## **WESLEY STATION SUBDIVISION, RESUBDIVISION OF LOT 1**

APPLICATION NUMBER 2 DATE November 15, 2018  
 APPLICANT Wesley Station Subdivision, Resubdivision of Lot 1  
 REQUEST Subdivision

# DETAIL SITE PLAN

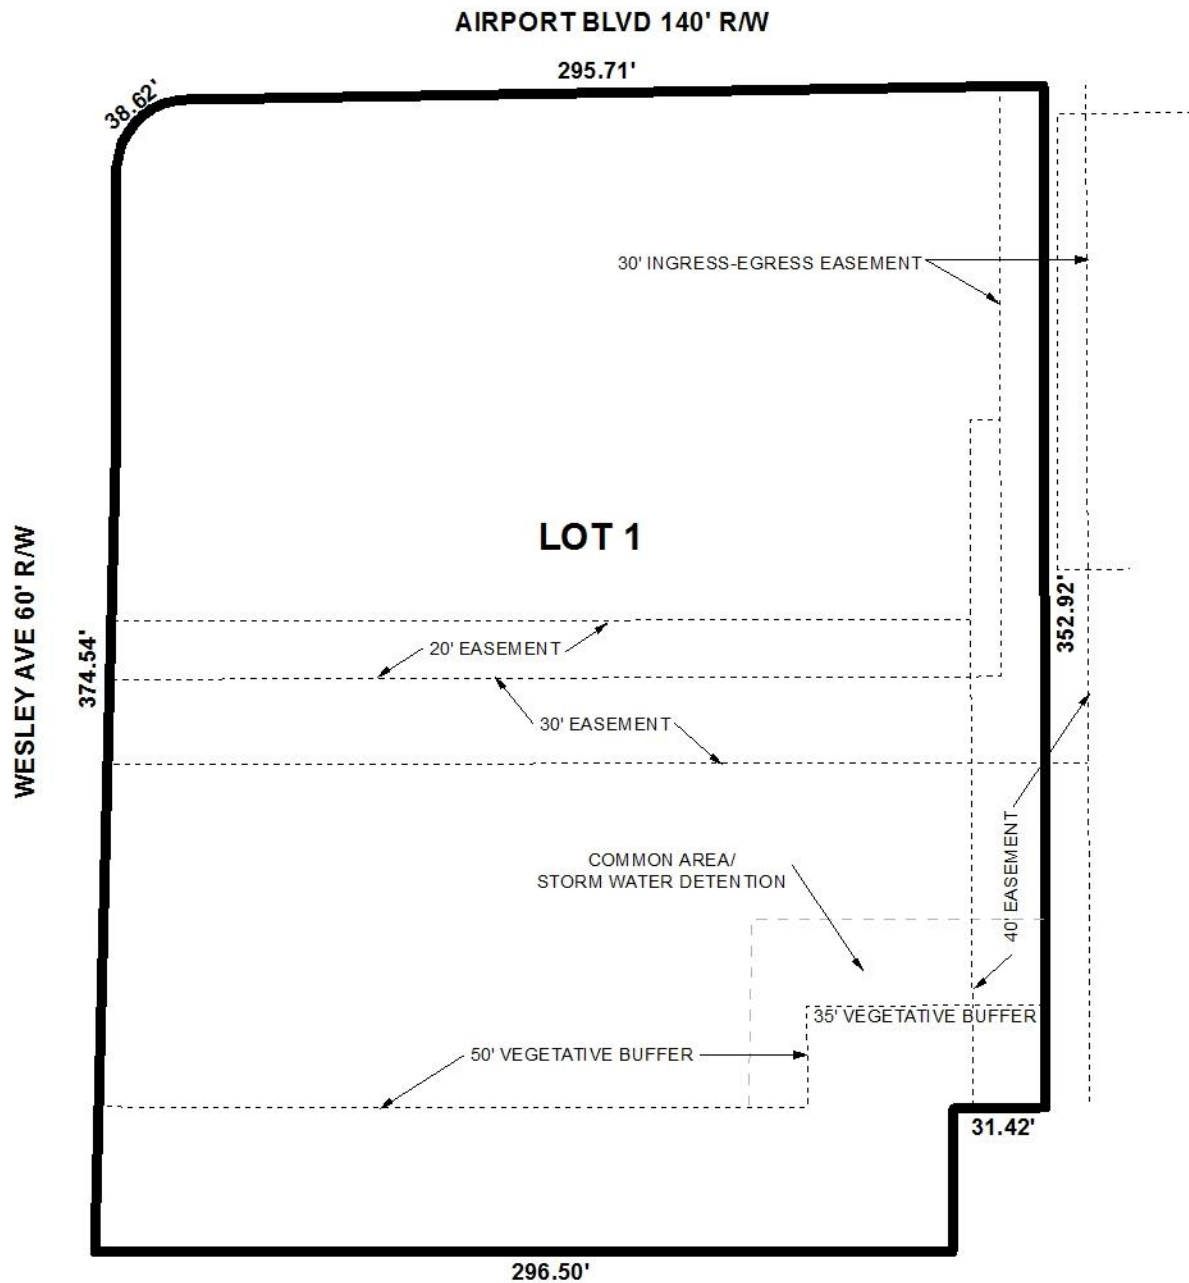
- B. Show and label the 15 foot wide proposed PUBLIC DRAINAGE EASEMENT shown in the plans for Land Disturbance permit ENG-027884-2018.
- C. Provide the Surveyor's, Owner's (notarized), Planning Commission, and Traffic Engineering signatures.

Traffic Engineering Comments: A 30' Ingress-egress common drive easement is illustrated on the eastern property line, however Traffic Engineering could not confirm if this easement is already recorded on Lot 2B as part of its previous subdivision plat in 2011. Lot 1 is limited to one curb cut to Wesley Avenue and one shared curb cut to Airport Boulevard with size, location and design to be approved by Traffic Engineering and conform to AASHTO standards. Any new on-site parking, including ADA handicap spaces, shall meet the minimum standards as defined in Section 64-6 of the City's Zoning Ordinance. The City has a pending sidewalk project along the Airport Boulevard frontage of this property. Depending on timeline of construction, Traffic Engineering will coordinate the construction plans for this site with the sidewalk construction plans through the right-of-way permitting.

The proposed lot fronts Airport Boulevard, a major street on the Major Street Plan, and Wesley Avenue, a minor street. The preliminary plat illustrates a compliant 140' right-of-way width on Airport Boulevard and a compliant 60' right-of-way width on Wesley Avenue. If approved, the right-of-widths should be retained on the Final Plat.

Because the site has two street frontages, a 25' minimum building setback is required along both Airport Boulevard and Wesley Avenue. The preliminary plat does not provide building setbacks. If approved, provision of 25-foot minimum building setbacks along both Airport Boulevard and Wesley Avenue will be required on the Final Plat.

It should be noted that there are several easements on the site: a 20' utility easement and a 30' common drive/utility easement bisect the site, a 30' ingress-egress common drive easement and a 40' drainage easement along the East property line, a 50' vegetative buffer is located along the Southern property line, and common area/ storm water detention and 35' vegetative buffer is illustrated in the Southeast corner of the property. If approved, a note should be placed on the Final Plat stating that no structures should be erected in any easement on the site.

The Wesley Station Subdivision, approved by the Planning Commission on December 2007, required an eight-foot wooden privacy fence as well as a vegetative buffer where the site adjoins residentially zoned property. The preliminary plat does not illustrate a fence. If approved, a note stating this requirement should be placed on the Final Plat. The 2006 approval also noted the following as a condition of approval: *Placement of a note on the Final Plat stating that no structures, parking or driveway(s) may be constructed within the southern 50' (between Wesley Avenue and Henckley Avenue).* If approved, the above note should be placed on the Final Plat.

As a means of access management, a note should be placed on the Final Plat, stating that Lot 1 is limited to one curb cut to Wesley Avenue and one shared curb cut to Airport Boulevard (on the East side of the property) with any changes in size, location and design to be approved by Traffic Engineering and conform to AASHTO standards.

- 1) Retention of the 140' right-of-way width to Airport Boulevard;
- 2) Retention of the 60' right-of-way width to Wesley Avenue;
- 3) Provision of a 25' minimum building setback line along both Airport Boulevard and Wesley Avenue;

- 4) Retention of lot size information in both square feet and acres;
- 5) Placement of note on the Final Plat stating that no structures should be erected in any easement;

- 6) Placement of a note on the Final Plat stating that no structures, parking or driveway(s) may be constructed within the southern 50' (between Wesley Avenue and Henckley Avenue);

- 7) Placement of a note stating that an eight-foot wooden privacy fence and vegetative buffer shall be located where the site adjoins residentially zoned property;

- 8) Placement of a note on the Final Plat stating the following Traffic Engineering comments: *(A 30' Ingress-egress common drive easement is illustrated on the eastern*

property line, however Traffic Engineering could not confirm if this easement is already recorded on Lot 2B as part of its previous subdivision plat in 2011. Lot 1 is limited to one curb cut to Wesley Avenue and one shared curb cut to Airport Boulevard with size, location and design to be approved by Traffic Engineering and conform to AASHTO standards. Any new on-site parking, including ADA handicap spaces, shall meet the minimum standards as defined in Section 64-6 of the City's Zoning Ordinance. The City has a pending sidewalk project along the Airport Boulevard frontage of this property. Depending on timeline of construction, Traffic Engineering will coordinate the construction plans for this site with the sidewalk construction plans through the right-of-way permitting.);
